**Conservation District Use Application
Hawaii Department of Transportation
Hanalei Valley Viewpoint at the Hanalei National Wildlife Refuge**

**Attachment C
Final Environmental Assessment**

Hanalei Valley Viewpoint Final Environmental Assessment

November 2019

Figure 1. Proposed Hanalei Valley Viewpoint

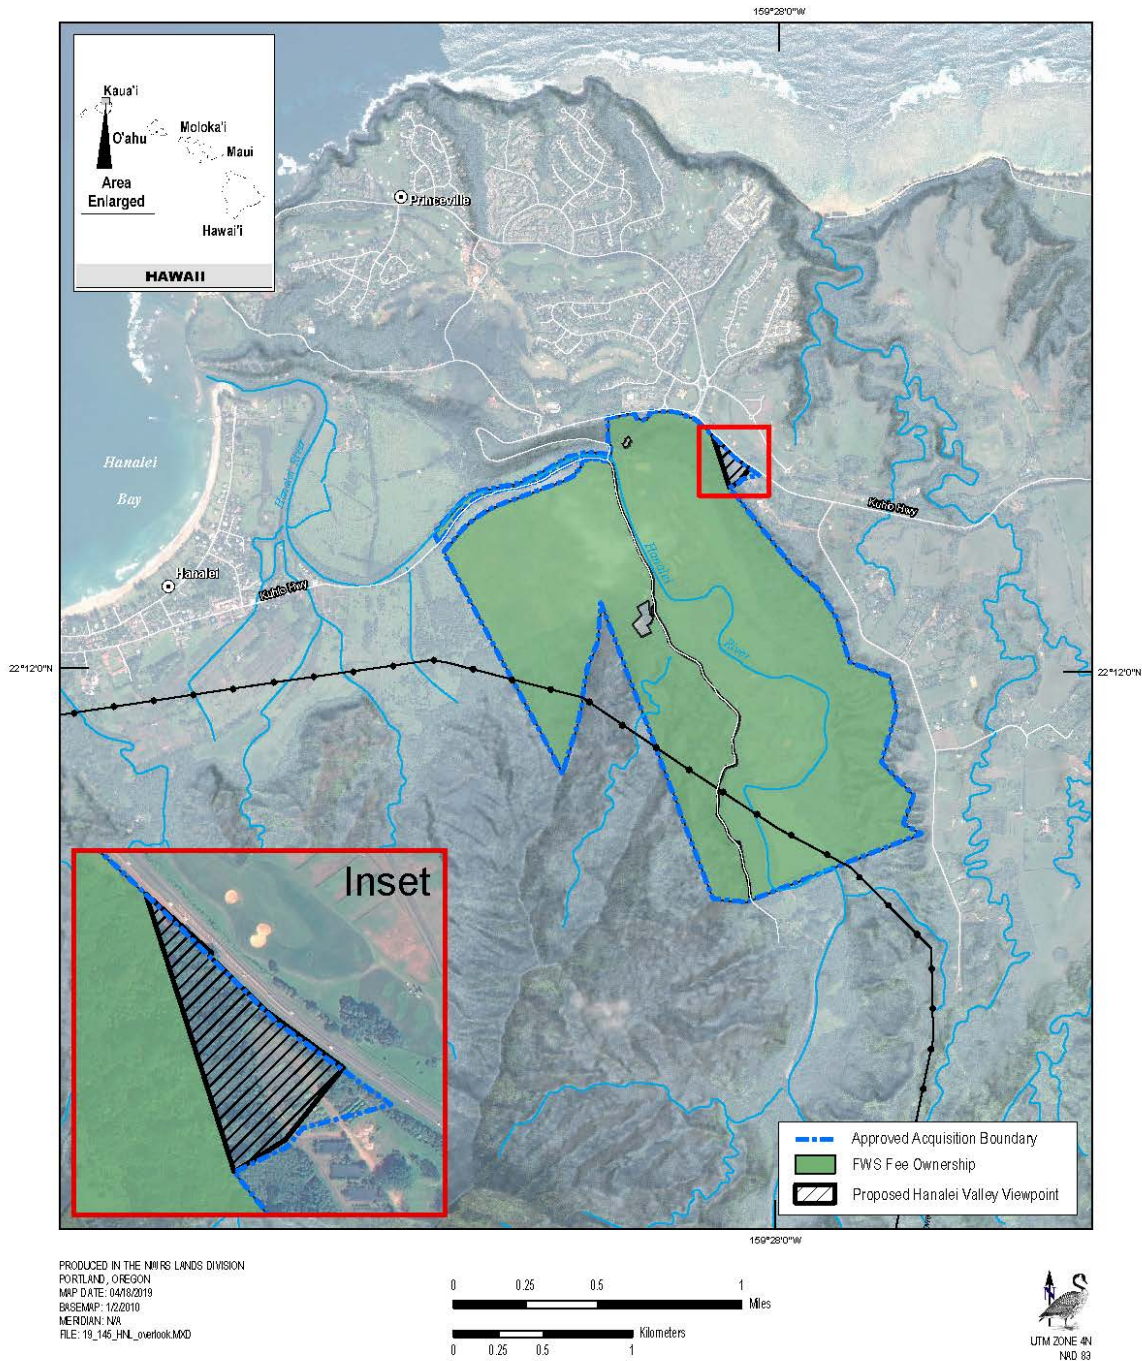
Comment 4. Figure 1 on page 14 of the document is confusing. The dashed line indicates an “approved acquisition boundary” while the shaded green area indicates “Fish Wildlife Service (FWS) fee ownership.” As the FWS already owns the shaded green portion, why is that within the approved acquisition boundary? In addition, the area shown to be owned by the FWS is not a part of parcel 16. We believe that this graphic should be updated to properly give perspective to the reader. We would suggest that a helpful location map would show the following: the proper TMK boundaries with labels; the location of the existing National Wildlife Refuge and the existing viewpoint; the location of the proposed viewpoint; and any lands to be acquired. To our knowledge Parcel 16, where the new viewpoint is to be constructed, is not owned by FWS and no acquisition has yet to have occurred.

Response to Comment 4: Figure 1 has been updated as requested and a more thorough discussion of the current landownership and land uses has been added to Section 2.2. An Approved Acquisition Boundary (AAB) merely identifies lands that have been approved to be added to the National Wildlife Refuge System (NWRS) from willing sellers. Once land is added to the NWRS it remains within the AAB.

Figure 2. Hanalei Valley Viewpoint Site Plan

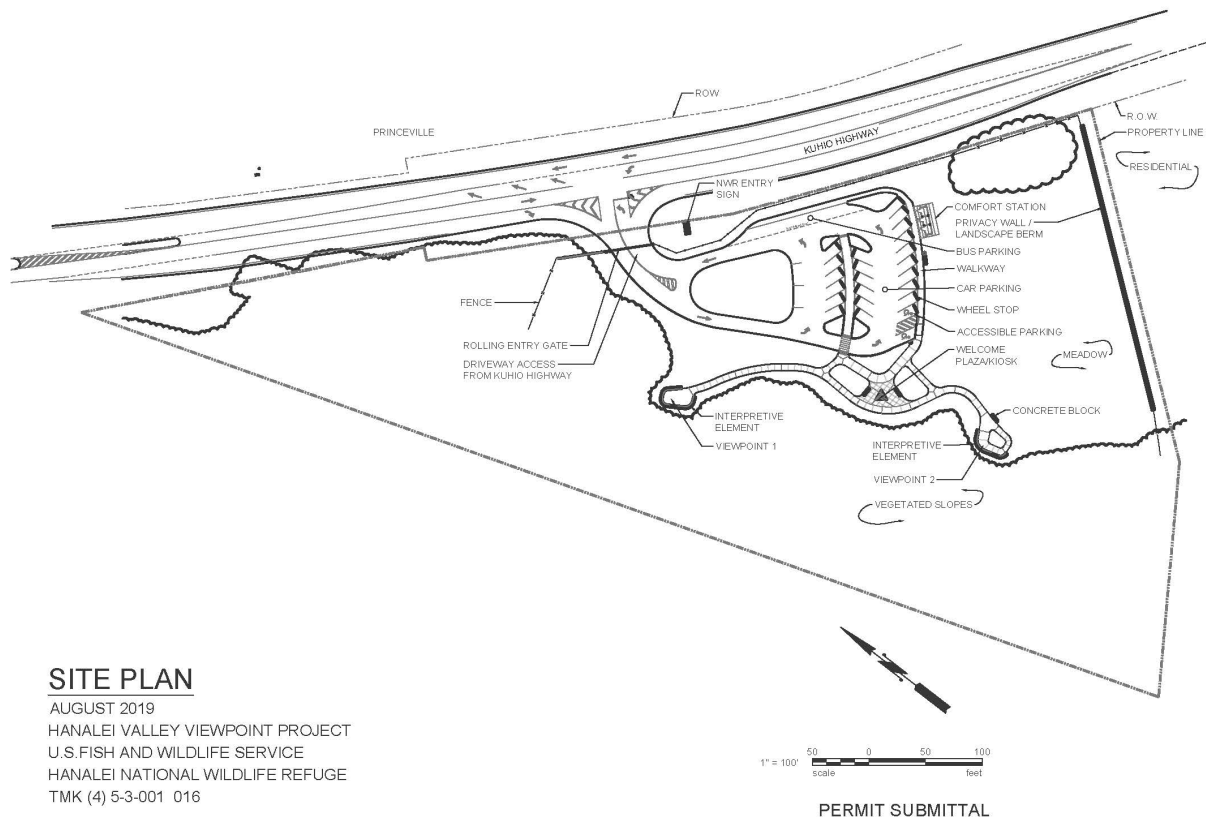
Comment 5. Figure 2 showing the site plan is illegible. It is less than half a page and when trying to zoom in from a pdf document, the graphic becomes grainy and blurry. The "key" is barely legible, and it is difficult to read the corresponding numbers on the graphic. Please revise all graphics so that they are legible so that agencies and the public can provide appropriate comments accordingly

Response to Comment 5: Figure 2 has been replaced with a more legible figure.
